Model: Aries-P1.5	Date: 04-Oct-10	No.: RM077001h
-------------------	-----------------	----------------

Subject: Firmware Release Note: Engine		Prepared by: T. Miyamoto	
From: 1st PP Tech Service Sect., PP Tech Service Dept.			
Classification:	<input type="checkbox"/> Troubleshooting <input type="checkbox"/> Mechanical <input type="checkbox"/> Paper path <input type="checkbox"/> Product Safety	<input type="checkbox"/> Part information <input type="checkbox"/> Electrical <input type="checkbox"/> Transmit/receive <input checked="" type="checkbox"/> Other (Firmware)	<input type="checkbox"/> Action required <input type="checkbox"/> Service manual revision <input type="checkbox"/> Retrofit information <input checked="" type="checkbox"/> Tier 2

This RTB has been issued to announce the firmware release information for the **Engine**.

59.Paper Exit Section 1 (D095/M0 / /)

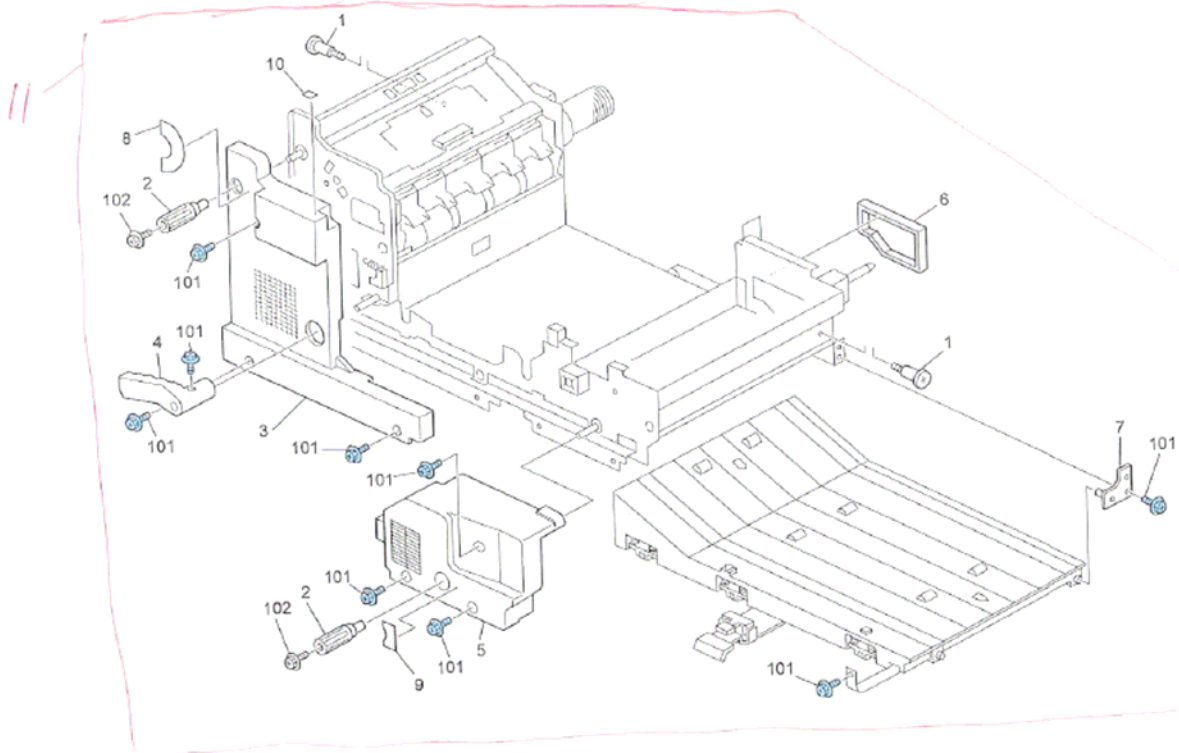
PCIL: October 2012
P/N change

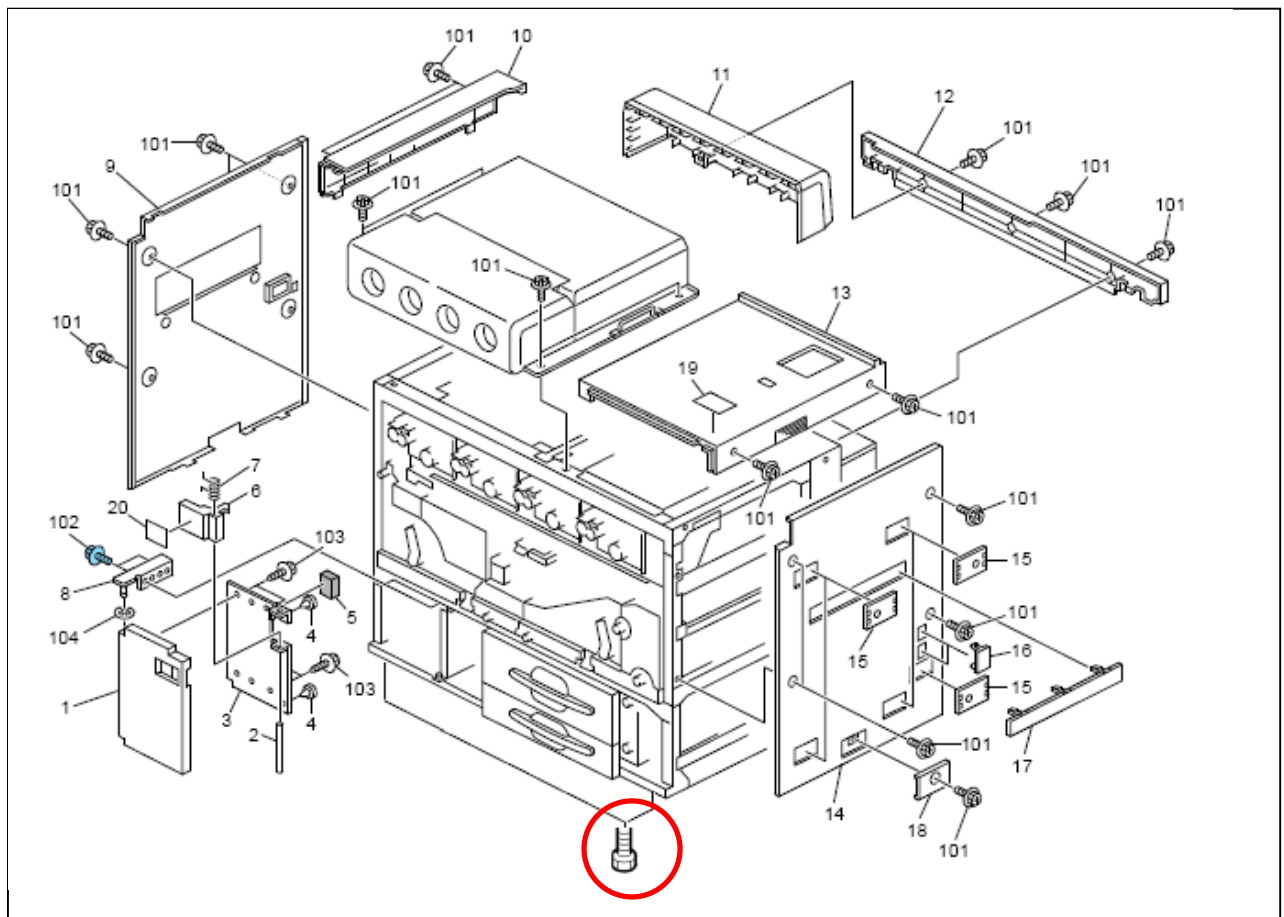
New part number	Description	Q'ty	Int	Page	Index	Note
G1781134	HEXAGONAL BOLT:M20X70	4	-	31	105

ITB GUIDE PLATE

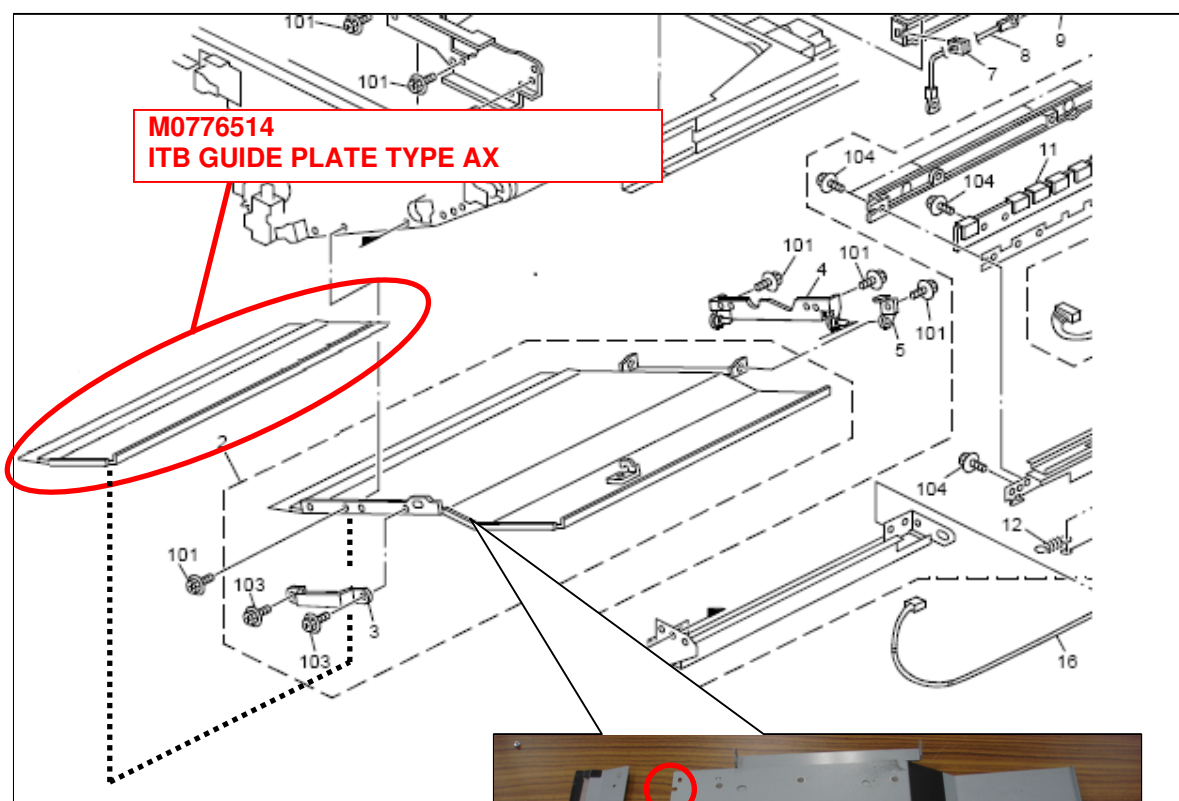
New part number	Description	Q'ty	Int	Page	Index	Note
M0776514	ITB GUIDE PLATE TYPE AX	1	-	101	17

M0774463 SUPPORTING PLATE:SIDE PLATE:REAR

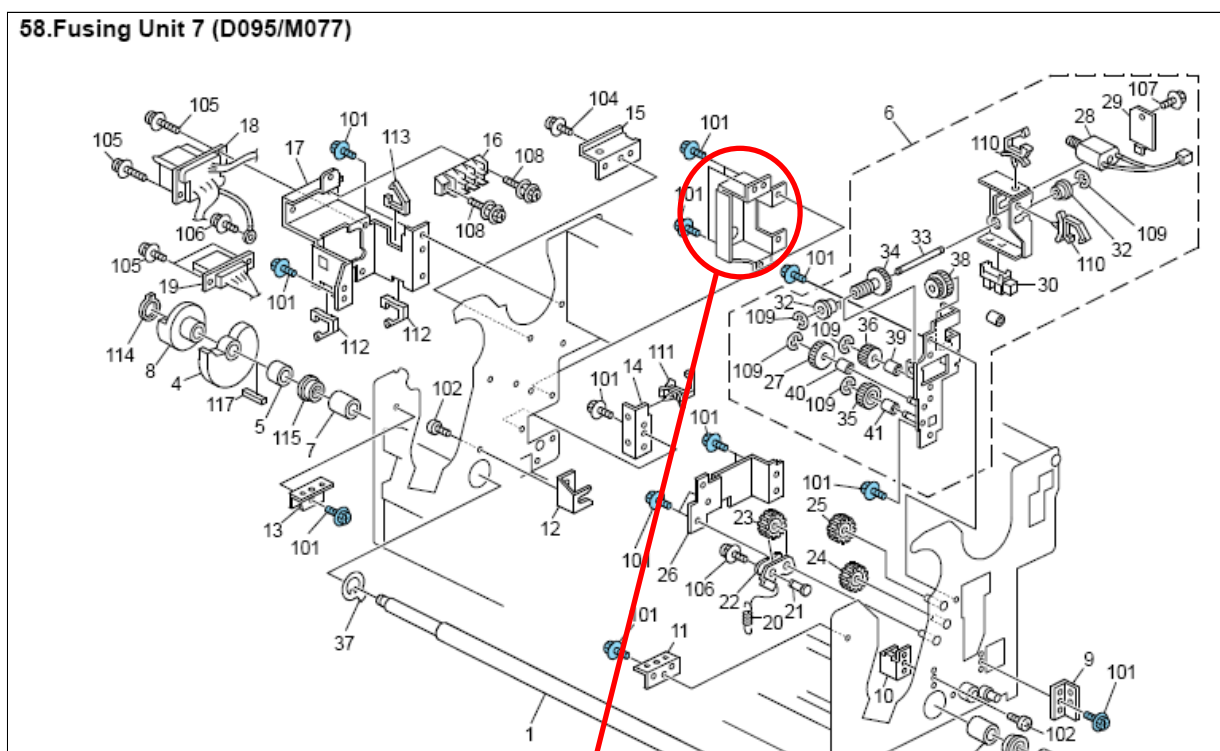
New part number	Description	Q'ty	Int	Page	Index	Note
M0774463	SUPPORTING PLATE:SIDE PLATE:REAR	1	-	141	42

38. Transfer Belt Unit 1 (D095/M077)

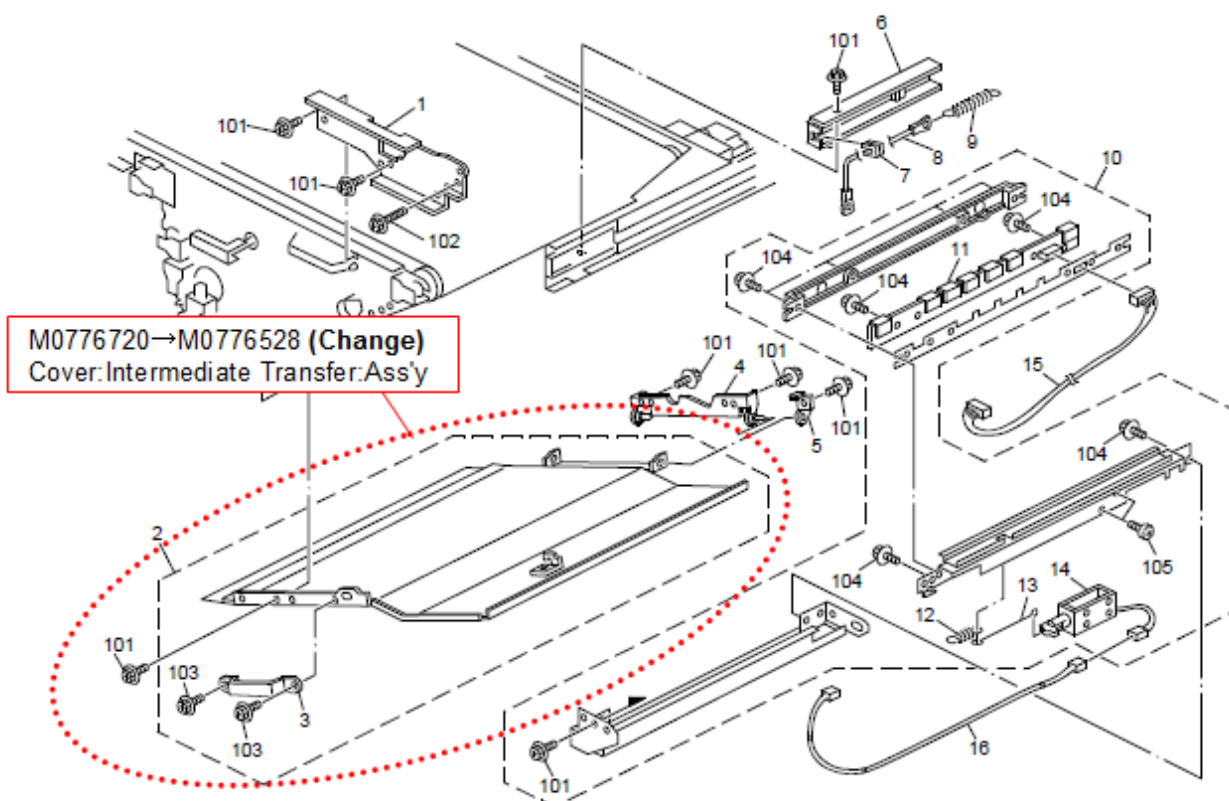
Type	Type AD	Type BX	Type BF	Type "AX" (See RTB RM077041 for detail.)
Part Number	M0776720	M0776528 + M0776527	M0776528 + M0776522	M0776720 + M0776514
Serial # (Serial # dependent)	Same with Type AX	T0105700001 and above V9905700001 and above	Same with Type BX	T01056xxxxx and below V99056xxxxx and below
Image quality problem occurrence rate				
Scratched image	High	Low	Low	Low
Low density	High	Low	High	Low
Jitter	High	Low	High	Low
Dark band	High	Low	High	Low
Poor image transfer at TE	High	Low	High	Low
Poor image transfer at LE	Low	Medium	Low	Medium

71.Paper Exit Section 13 (D095/M077)

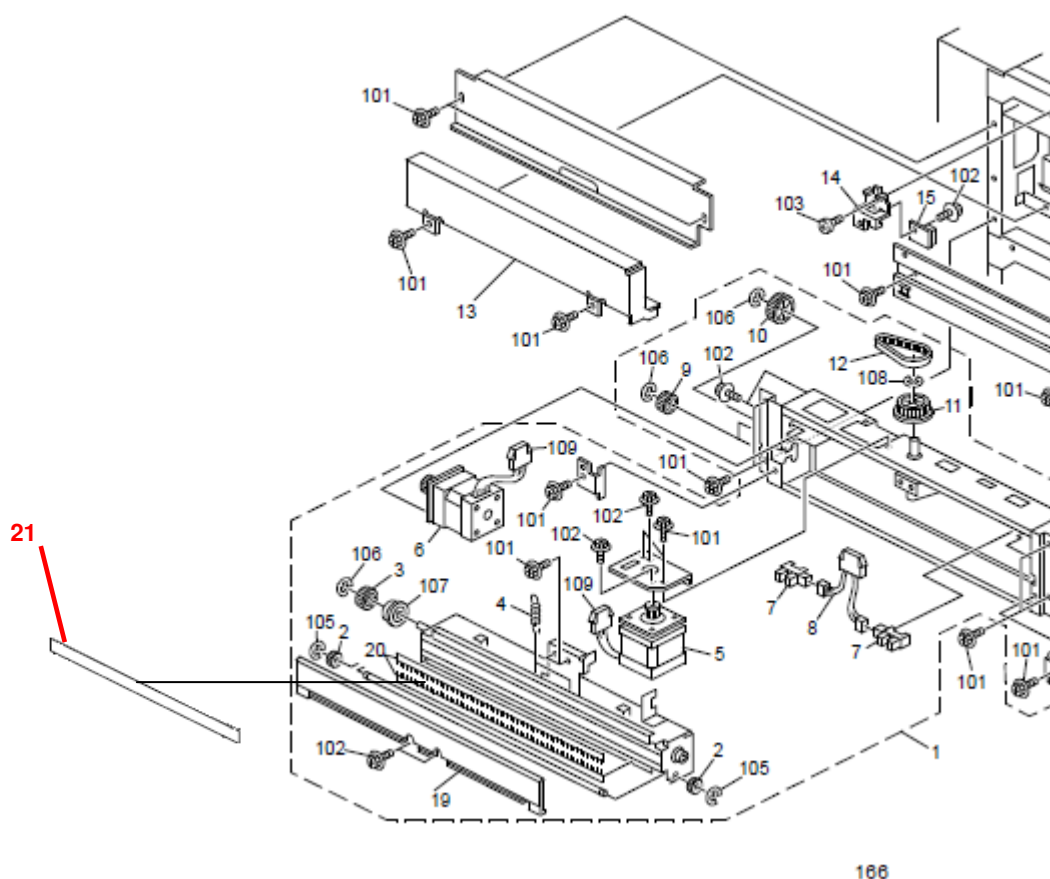
New part number	Description	Q'ty	Int	Page	Index	Note
M0774706	SHEET:DECURA:MIDDLE	1	-	166	21

65.Paper Exit Section 7 (D095/M077)

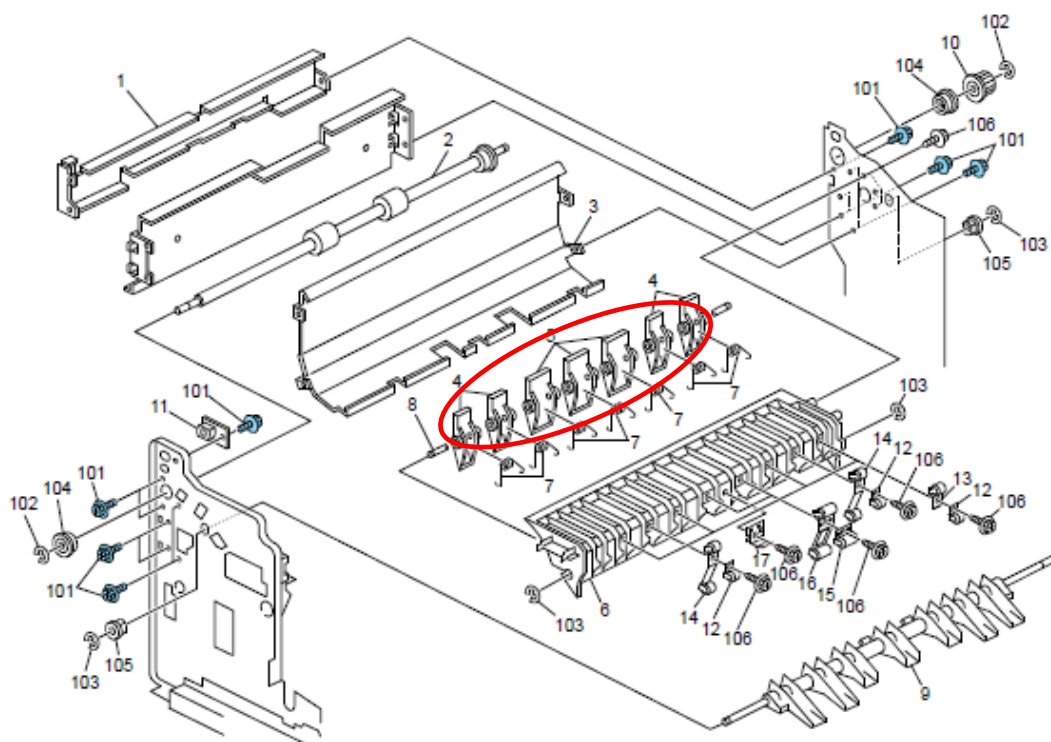
*NOTE 1: Interchangeability is X/O as a set.

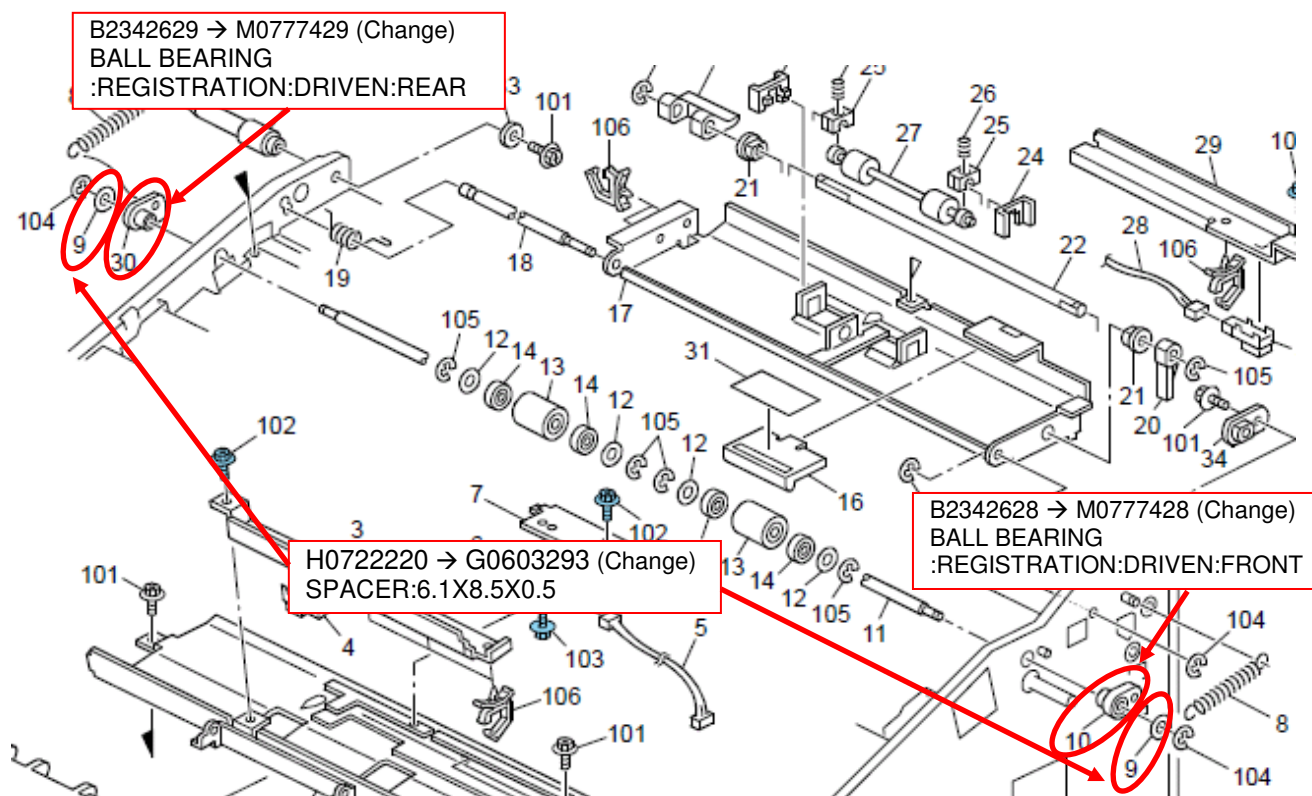
Old Part Number	New Part Number	Description	Q'ty	Int	Page	Index	Note
B2342628	M0777428	BALL BEARING :REGISTRATION:DRIVEN:FRONT	1	X/O	63	10	Change
B2342629	M0777429	BALL BEARING :REGISTRATION:DRIVEN:REAR	1	X/O	63	30	Change
H0722220	G0603293	SPACER:6.1X8.5X0.5	2	X/O	63	9	Change

NOTE: When replacing the above parts, replace all 3 parts as a set.

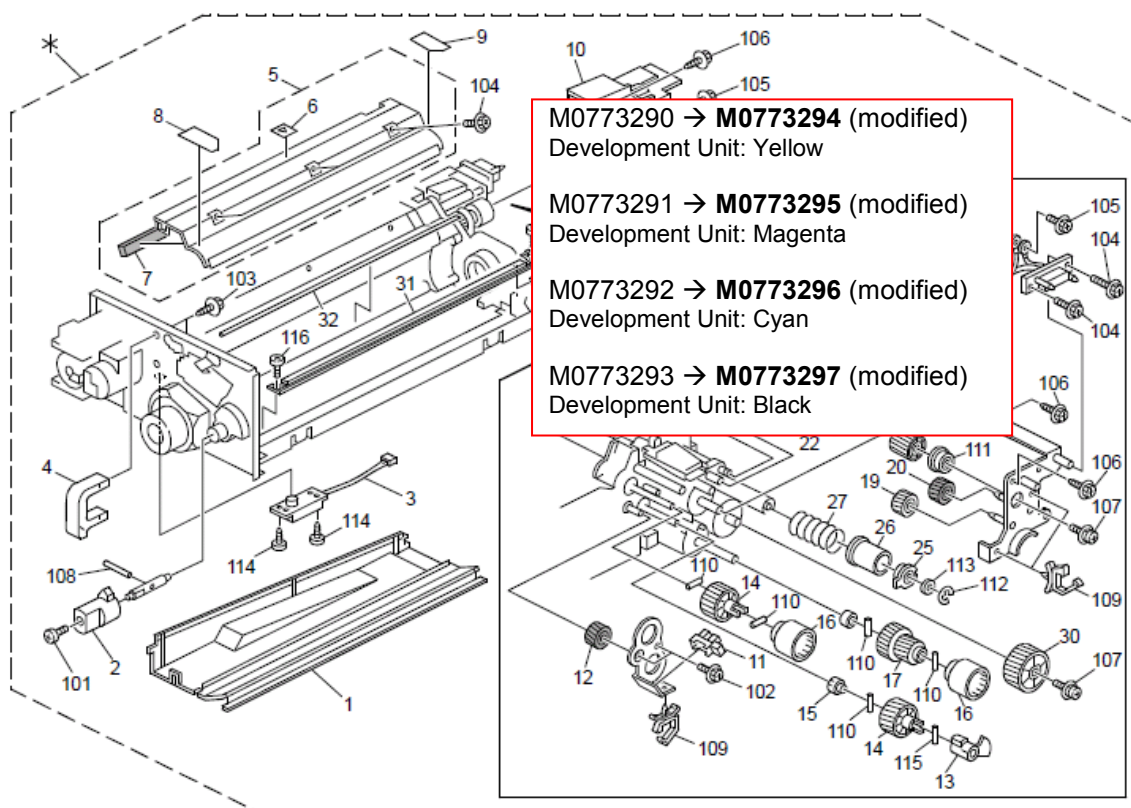
Old Part Number	New Part Number	Description	Q'ty	Int	Page	Index	Note
M0773290	M0773294	Development Unit: Yellow	1	O/O	95	*	Change
M0773291	M0773295	Development Unit: Magenta	1	O/O	95	*	Change
M0773292	M0773296	Development Unit: Cyan	1	O/O	95	*	Change
M0773293	M0773297	Development Unit: Black	1	O/O	95	*	Change

54.Fusing Unit 3 (D095/M077)

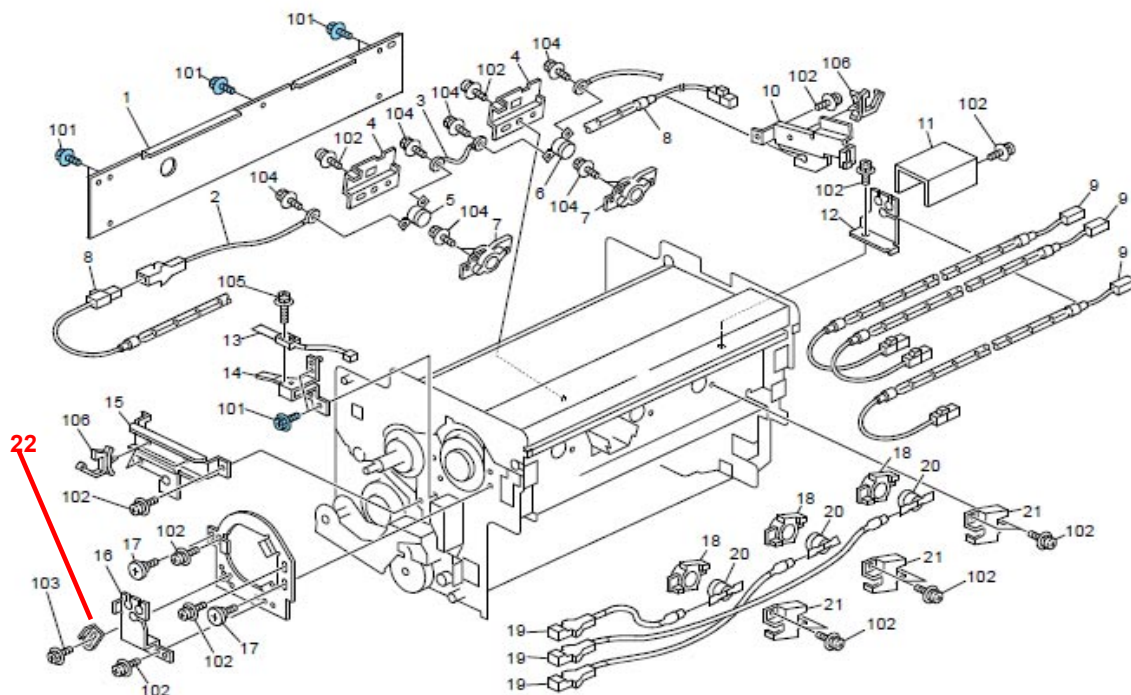
New part number	Description	Q'ty	Int	Page	Index	Note
M0774414	PIN:ADJUSTING PIN:HEAT ROLLER:PEEN	1	-	133	22

p/nD5324671
TRAY BOTTOM PLATE:AUXILIARY:FRONT:PEEN

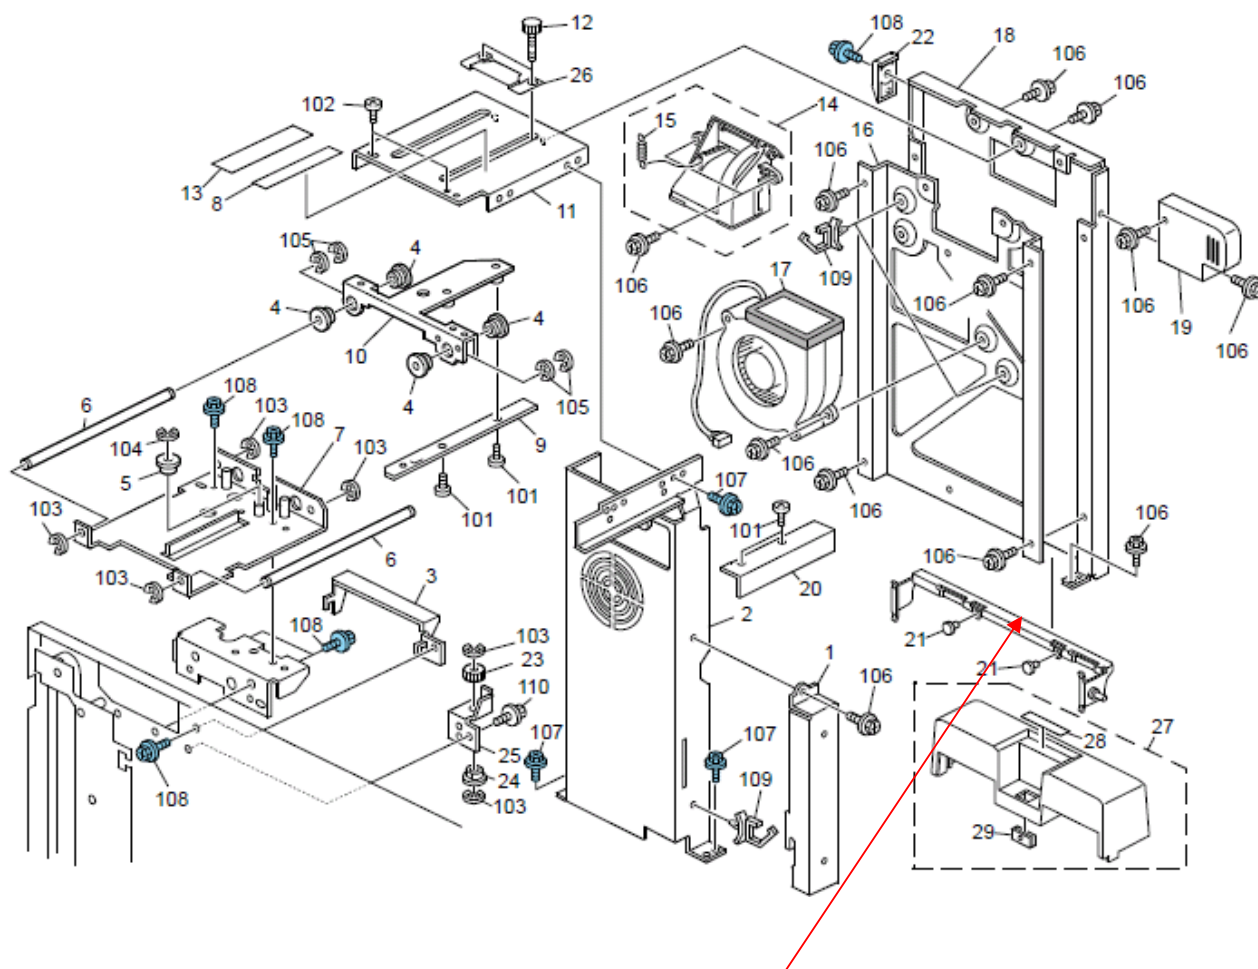
New part number	Description	Q'ty	Int	Page	Index	Note
D5324631	TRAY BOTTOM PLATE:AUXILIARY:REAR:PEEN	2		273	16	
D5324671	TRAY BOTTOM PLATE:AUXILIARY:FRONT:PEEN	2	-	273	17
